GRANDVIEW RESERVE - PHASE 2
D.R. HORTON
EL PASO COUNTY, CO

EARLY GRADING & EROSION CONTROL PLANS
TYPICAL SECTION

EARLY GRADING & EROSION CONTROL PLANS
GEC INITIAL

SHEET
GEC
3

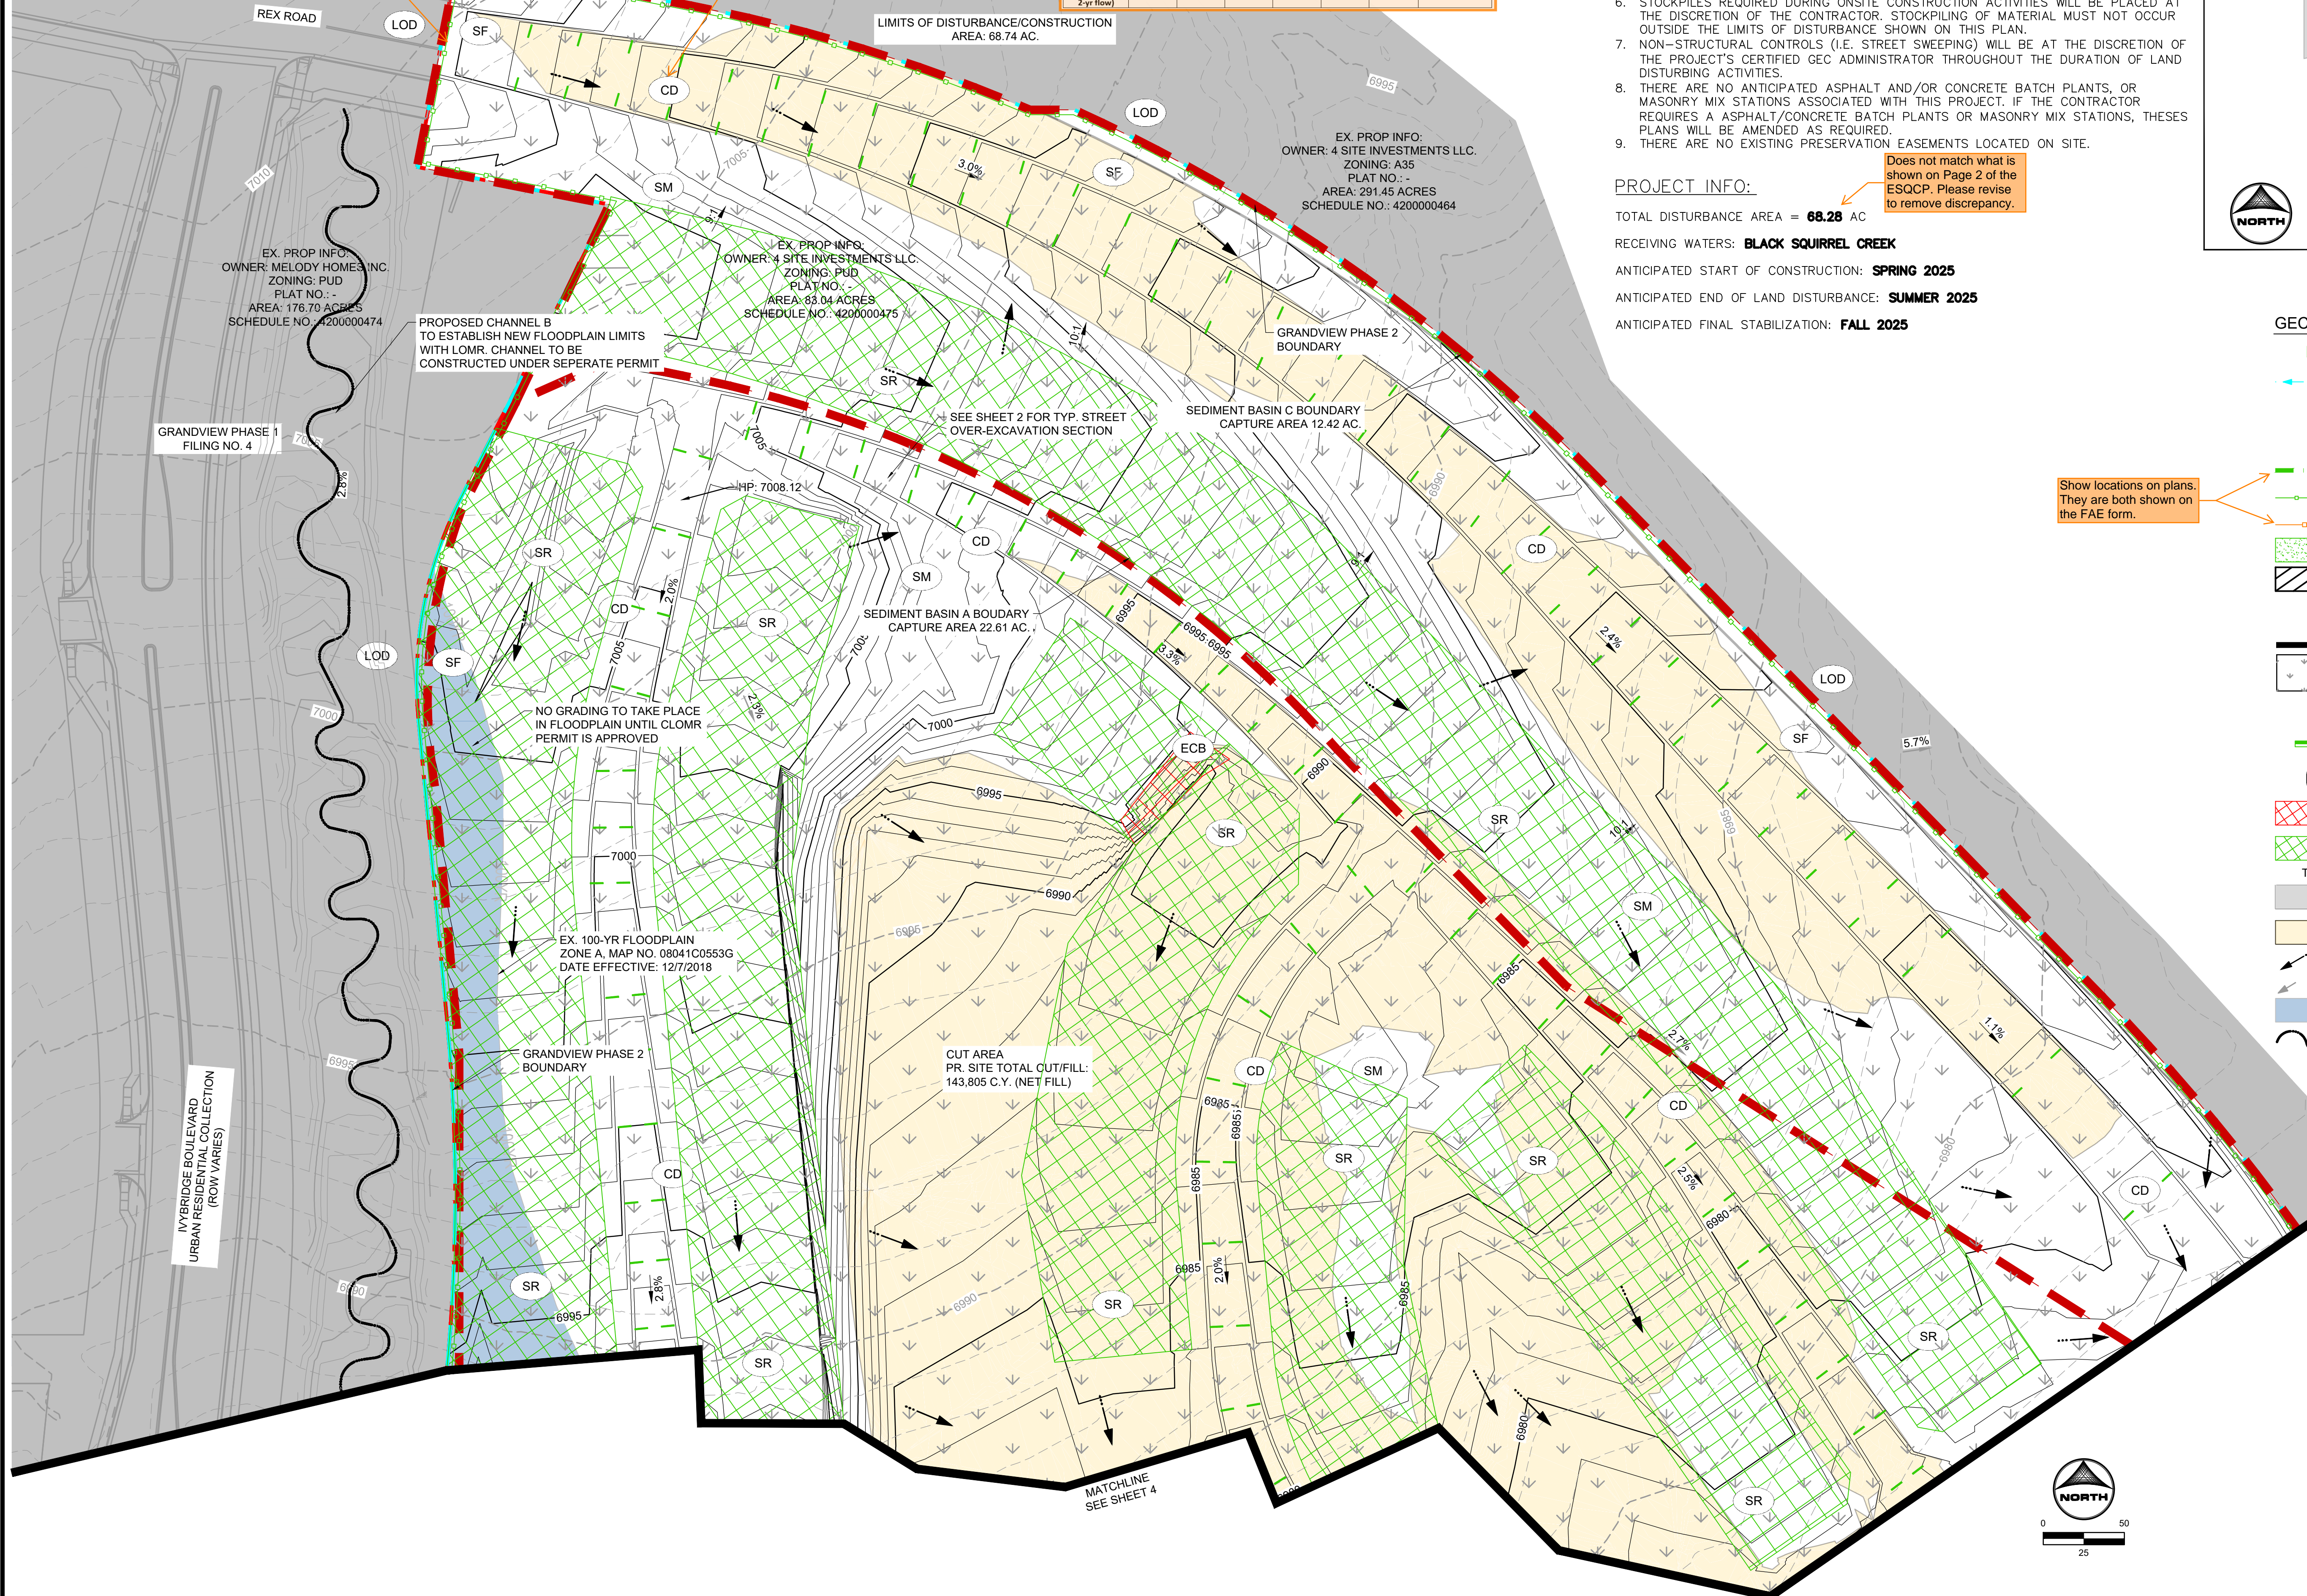
GEC Checklist Item W, Show VTC here or provide construction fencing, barricades, and/or signage at access points not to be used for construction.

Check dams to be installed a minimum of every 1.5' of vertical fall. Note spacing and/or include a table for multiple slopes, based on your selected detail, per the example table provided:

Does not match what is shown on Page 2 of the ESQCP. Please revise to remove discrepancy.

GEC Checklist Items H and M. If "limits of disturbance" and "construction boundary" are the same, change to "limits of construction/disturbance" or otherwise show as separate line types for each on the legend and figure.

Show locations on plans. They are both shown on the FAE form.
